ITU-T G.722.2

Implementors' Guide for G.722.2

***(Wideband coding of speech at around 16 kbit/s
using Adaptive Multi-rate Wideband, AMR-WB)***

Implementors' Guide for Recommendation G.722.2

Figure 2 Detailed block diagram of the ACELP encoder

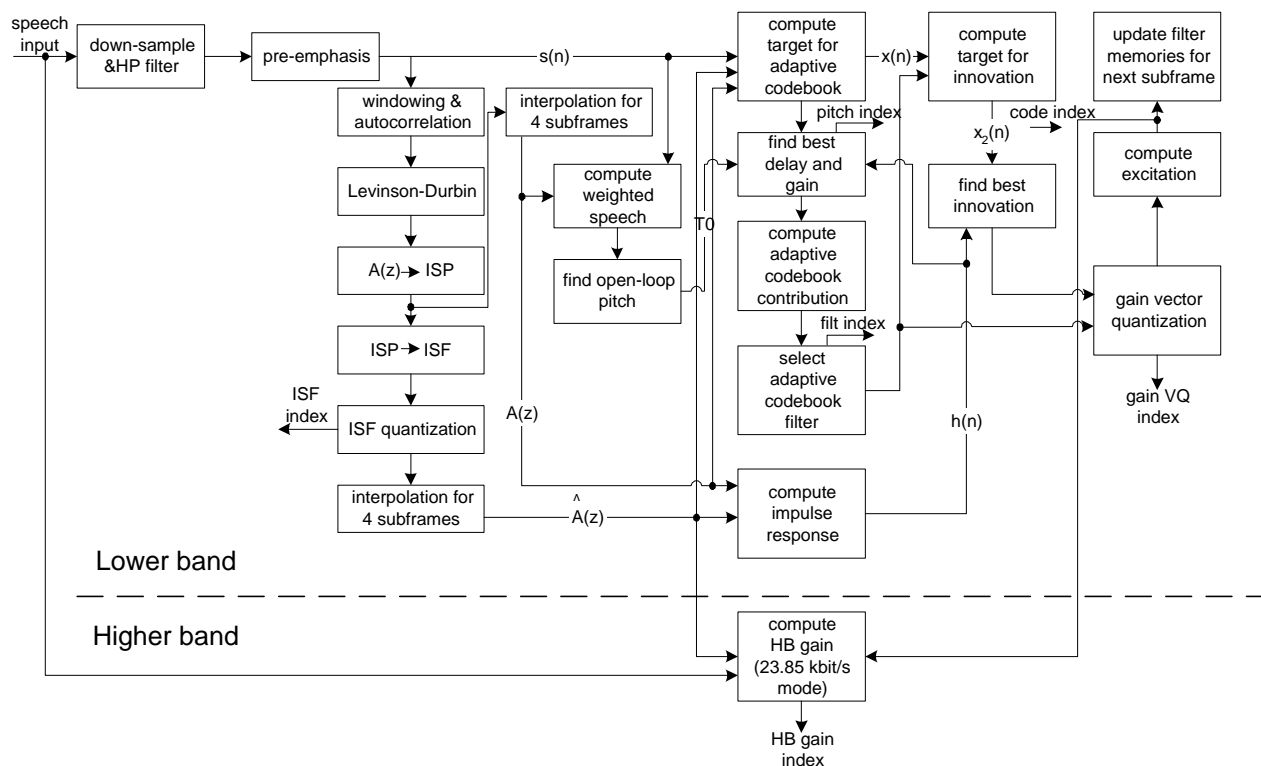
6.1.9 G.722.2 Figure 2 and 3

Description:	Editorial correction (only correct versions of Figure 2 and 3 presented)
---------------------	--
